CONTRACT CHANGE ORDER NO. ____
SHEET ___ OF ___

SAN FRANCISCO OAKLAND BAY BRIDGE
EAST SPAN SEISMIC SAFETY PROJECT
SELF-ANCHORED SUSPENSION BRIDGE
(SUPERSTRUCTURE & TOWER)

TOWER ANCHORAGE DETAILS NO. 9

BASE PLATE TEMPLATE (See Note 1)

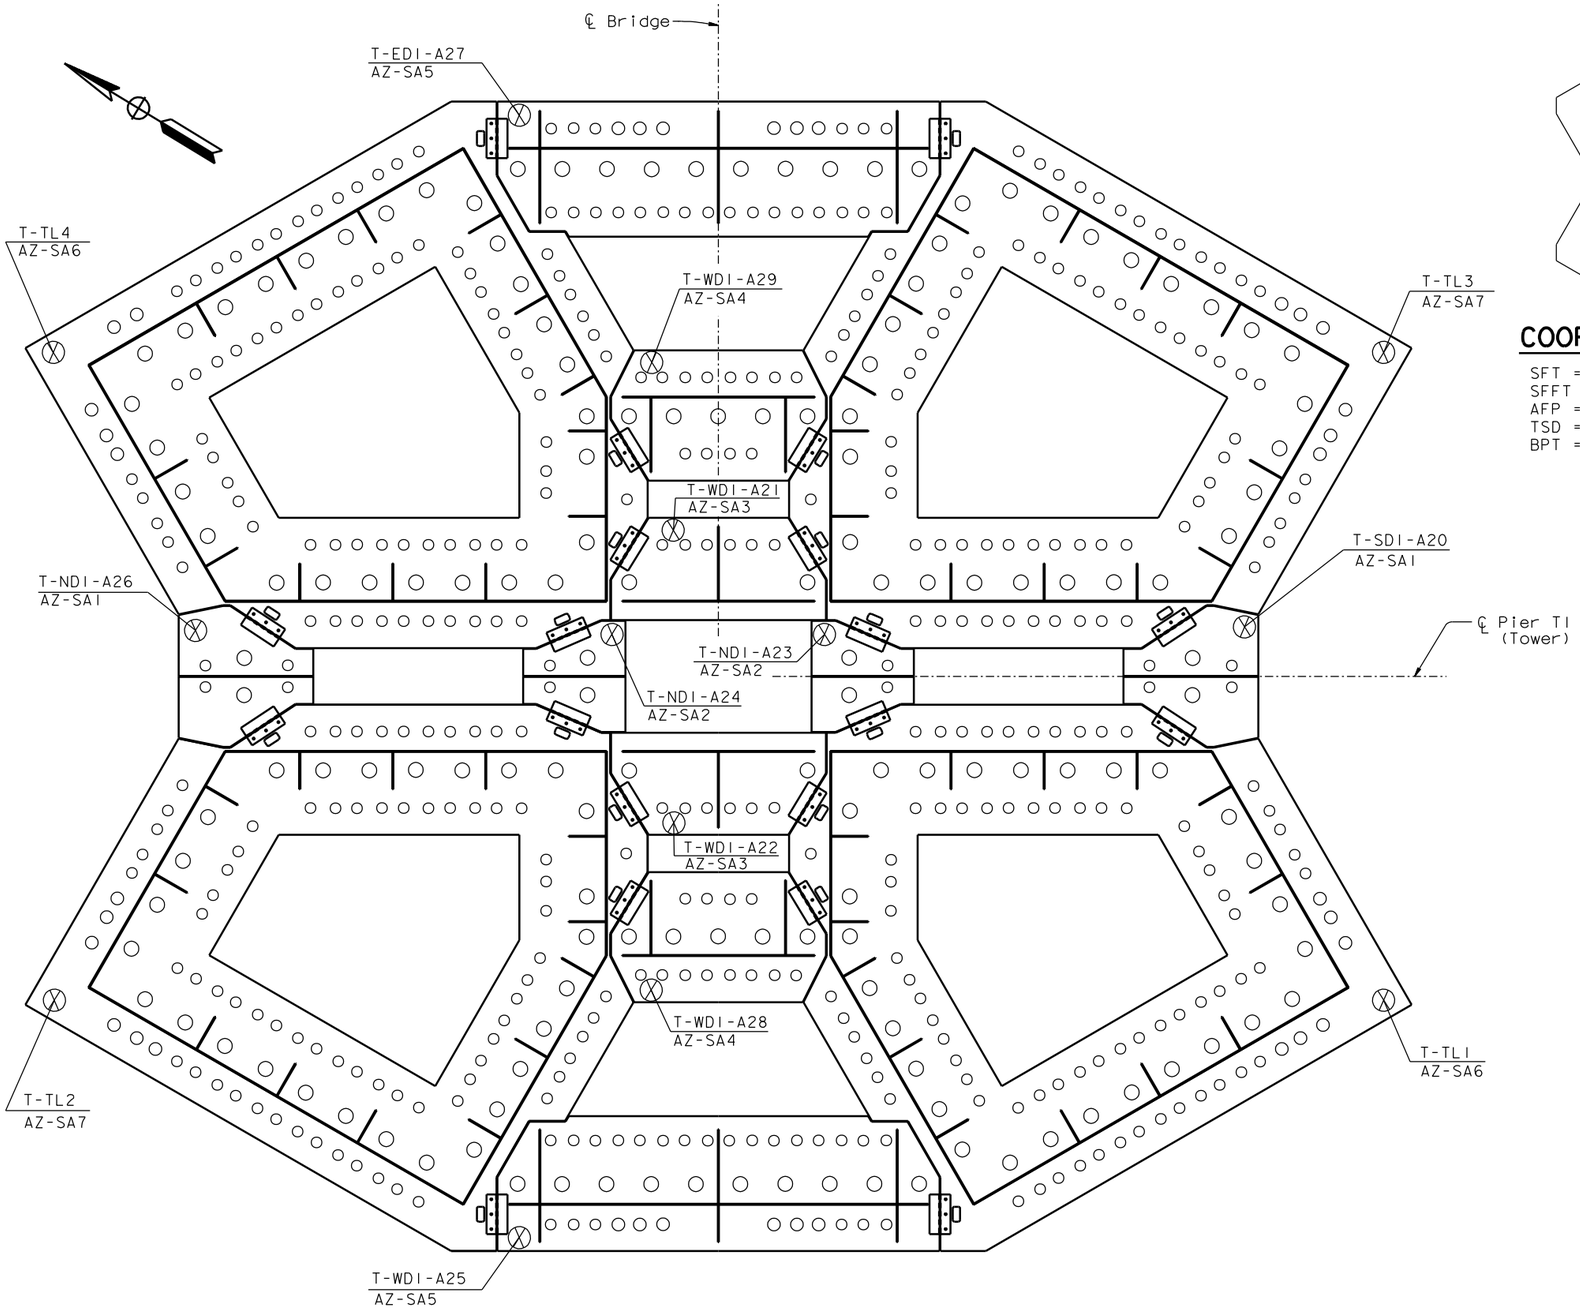
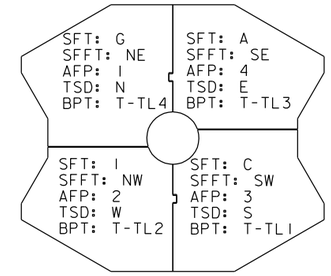
MARK	DATE	DESCRIPTIONS	BY	CH'D	CCO#
1	11/07/08	TOWER BASE PLATE TEMPLATE	JD	MN	67
0	06/20/08	TOWER BASE PLATE TEMPLATE	JD	MN	67

1. The flatness of the base plate template shall be within ±5 mm of the overall X and Y dimensions of the permanent tower base plate.
2. The base plate template shall be made of same number of pieces and configuration as the permanent tower base plates being erected as part of the permanent structure.

3. The base plate template pieces shall be the same external size and shape as the permanent tower base plates.
4. Holes in the base plate template shall be the same diameter as the holes in the permanent tower base plates.

5. The holes in the base plate template shall be located to match the holes in the State Furnished Template and State Furnished Field Templates to within ±3.0 mm.

6. The reference lines on the State Furnished Template shall be marked on the base plate template within ±1.0 mm.
7. The tower Working Points (WP) at Elevation 3.125 m shall be marked on the punch plate for all tower shafts.
